# CHANGE ORDER

Project Name: **Haverhill Consentino Middle School** CO No. **13**

Architect's Project No. **21-0818**

See attached list of 6 item(s) for a total of .....\$93,591.12

**F9** ENLARGED STAIR SECTION - HELLERUP (STAIR 7)  
1/4" = 1'-0"

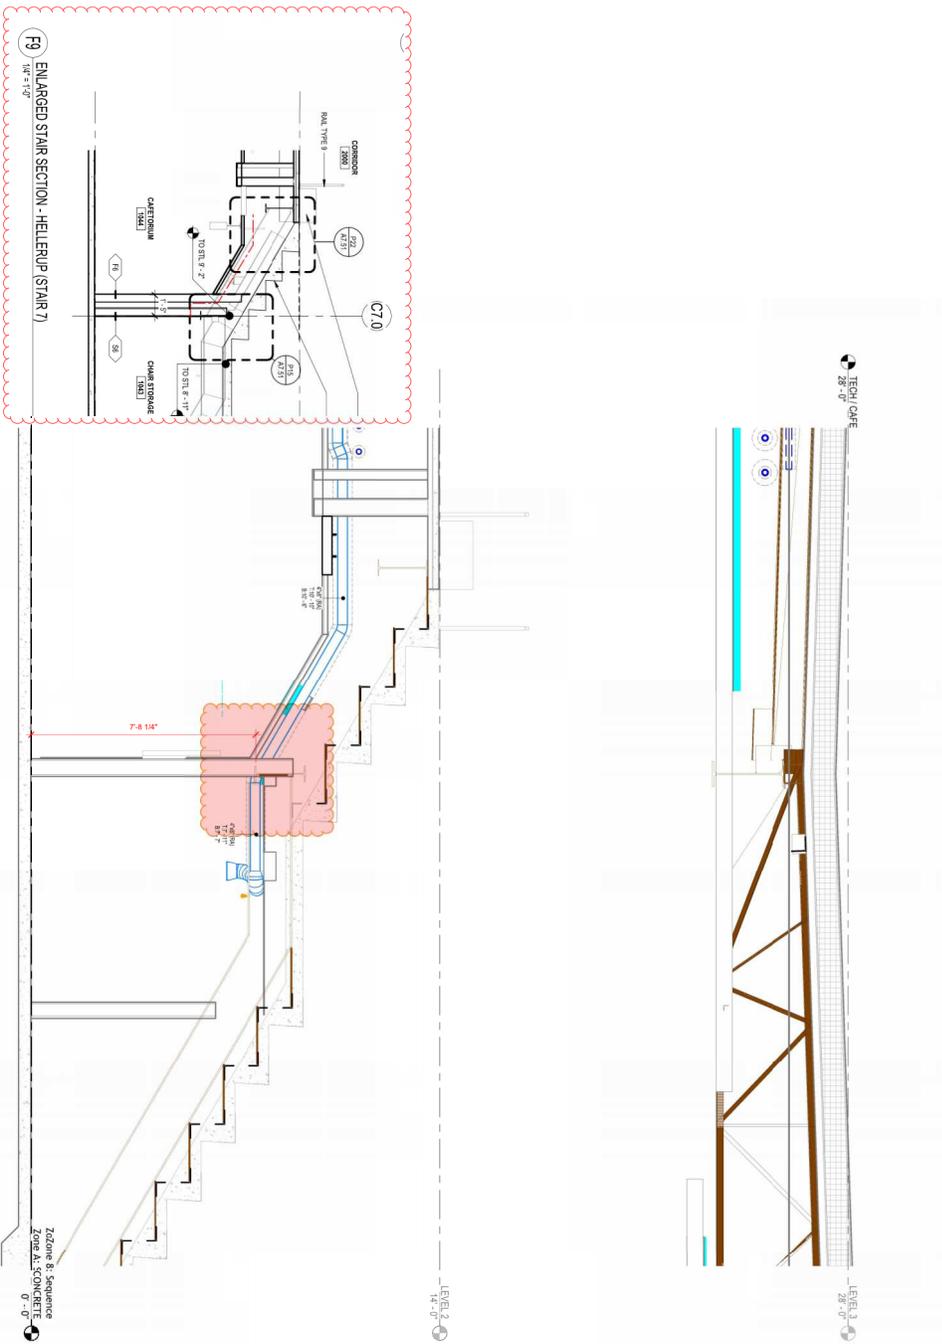
The ductwork for the return grill in Chair Storage 1043 is in conflict with a steel beam under the staircase that runs the width of the staircase. There does not appear to be enough room between the bottom of the beam ( 7'- 8 1/4") and the ceiling under the stairs to fit the ductwork through.

Refer to GGD comments provided within. Design team recommends created a dual wall condition to allow the duct to drop below the beam. A1 wall to be revised to S6 shaft wall, and new F6 chase wall to be roughly 1'-5" to the North of grid C7.0. Mechanical contractor to confirm if dimension allows enough room for duct to pass. Bottom of sloped ceiling to be roughly 8'-0 1/2". Team to provide formal PR following updated coordination.

*The submittal and approved diffuser shall change from a ceiling installation to side wall installation. Refer to Arch. Sketch for the new soffit for the duct to enter the space below the steel beam noted below the stair.*

SHEET NUMBER  
**A1.40**

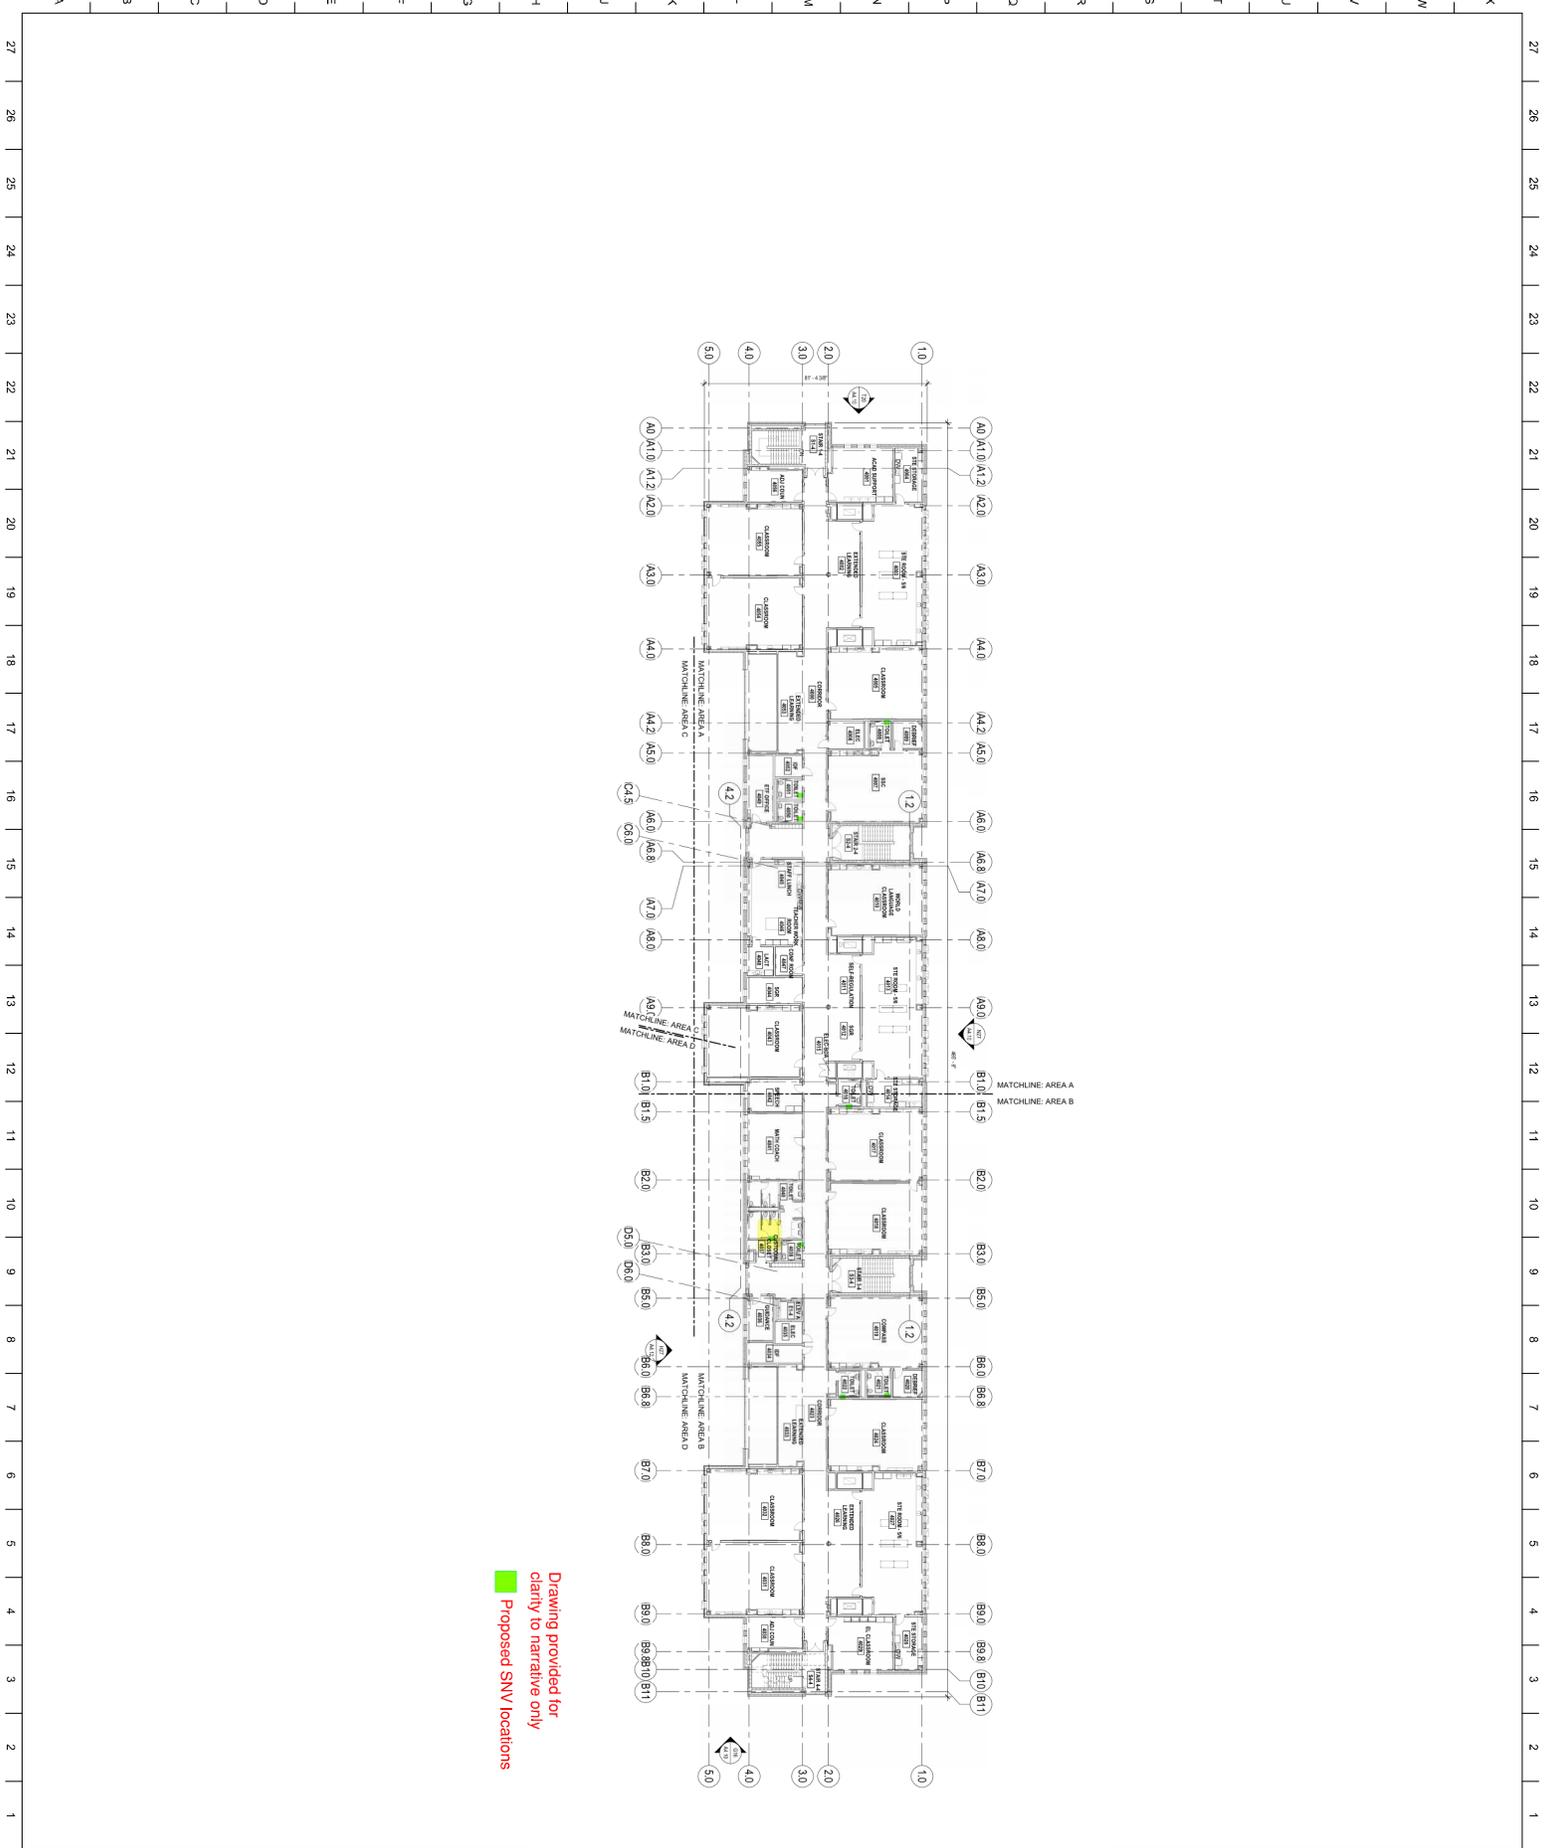
To coordinate with Submittal 10 28 00 - 002 Bathroom Accessories Package-RR-RSC, provide sanitary napkin vendors at the locations indicated below:

Drawing provided for  
clarity to narrative only  
Proposed SNV locations

## JD-107

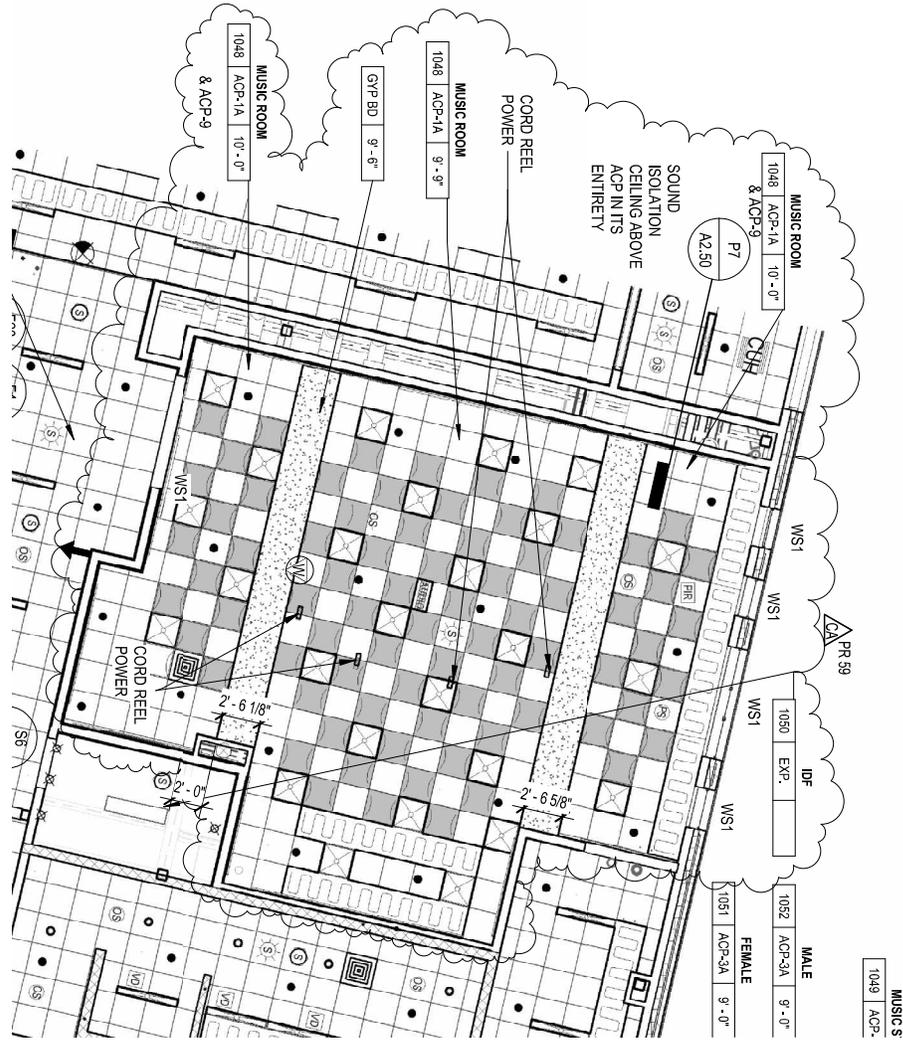
To coordinate with contractor coordination, at Sheet A2.14, Level 1 Reflected Ceiling Plan, Area D, revise Music Room 1048 ceiling as shown on the attached sketch **JD-107**.
